FEDERAL COMMUNICATIONS COMMISSION
445 12th Street, SW
Washington, DC 20554

In re: K210CL Translator, Lemon Grove, CA
Santa Monica Community College District
BPFT-20020328AAT
Facility ID: 90642

This refers to the above-captioned minor application to change antenna type and increase the effective radiated power.

call	serv	city,state	application no.	contour	chan	erp	hant	rcamsl	coverage area	AI
K210CL	FX	LEMON GROVE,CA	BPFT-20020328AA1	100.0 dBu (50,10)	210D	0.010	552.6	797.0	0.0 sq km	72
KPBS-F	FM	SAN DIEGO,CA	BLED-19841121LZ	60.0 dBu (50,50)	208B	1.750	580.0	807.0	7385.1 sq km	0

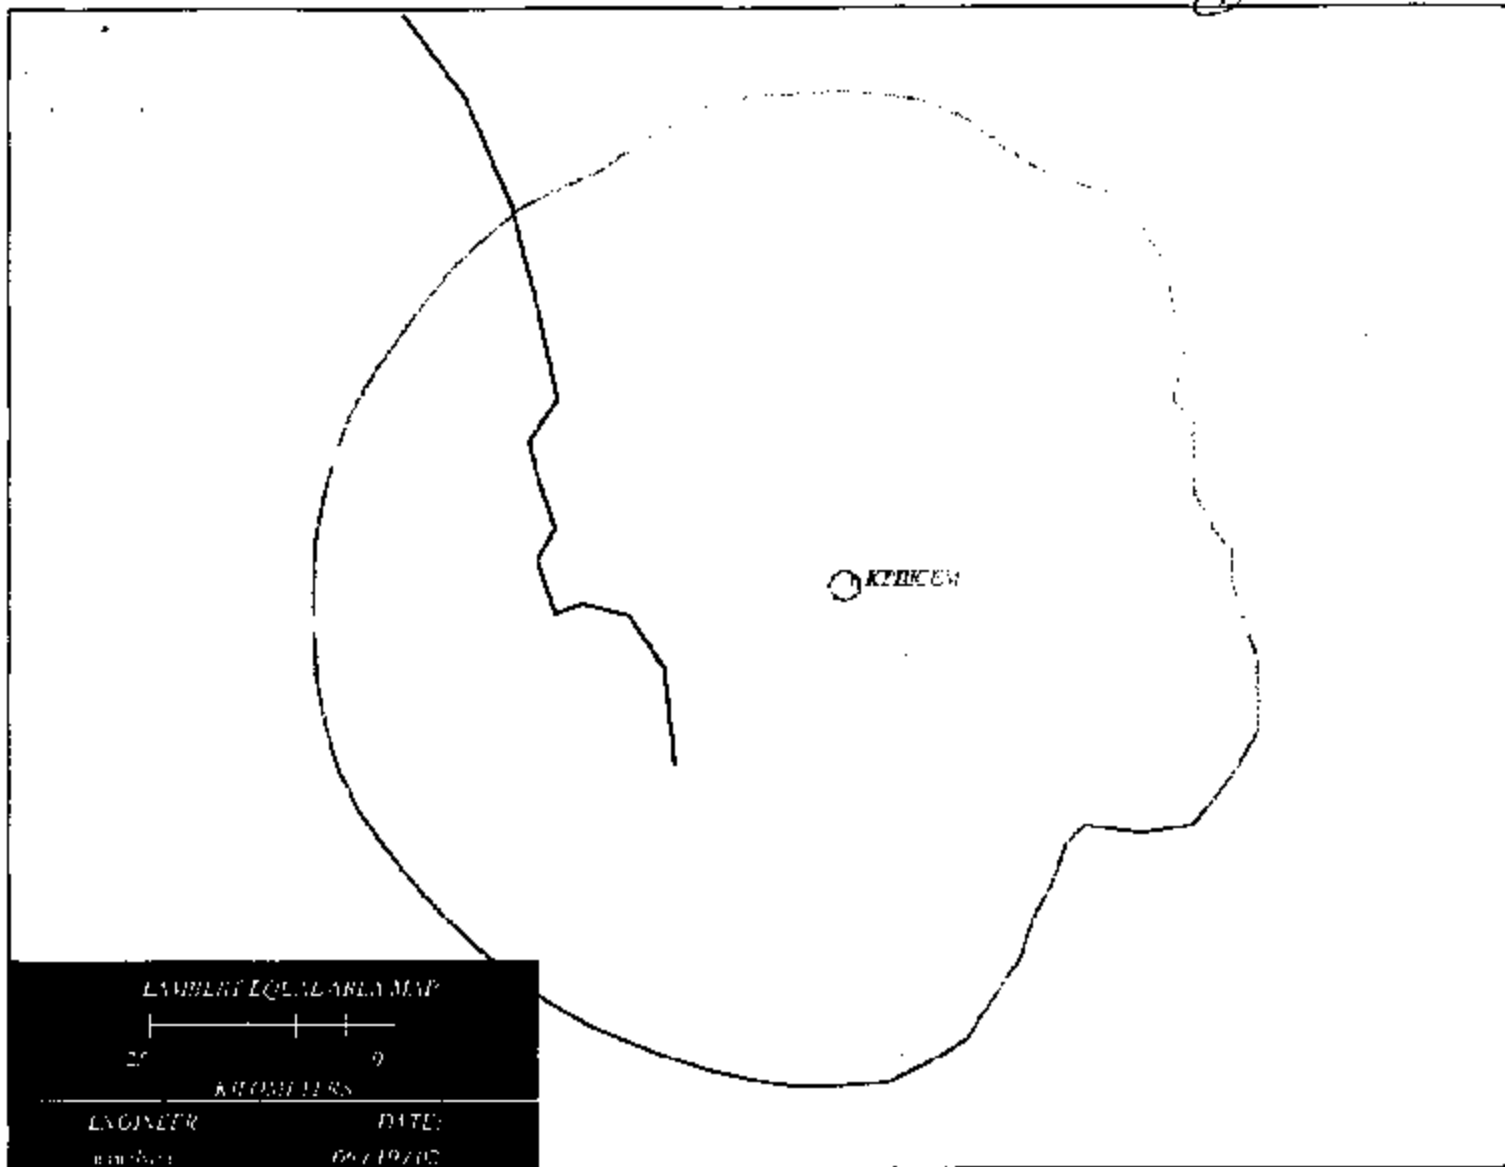
Our engineering study of the application reveals that it is in violation of 47 C.F.R. § 74.1204(a) with respect to the second-adjacent authorized facilities of KPBSFM, San Diego, CA. (License: BLED-19841121LZ and Construction Permit: BPFD-19970211A). Section 74.1204(a) states that an application for an FM translator station will not be accepted if the proposed operation would involve prohibited overlap of predicted field strength contours with any other authorized station. The proposed 100 dBU interference contour overlaps the protected 60 dBU contours of KPBSFM, (see attachments). Applicant recognizes this violation and requests a waiver on the basis that the site is mountainous and unpopulated. To comply with Section 74.1204(d), the applicant must demonstrate that no actual interference will occur to the overlapped station.
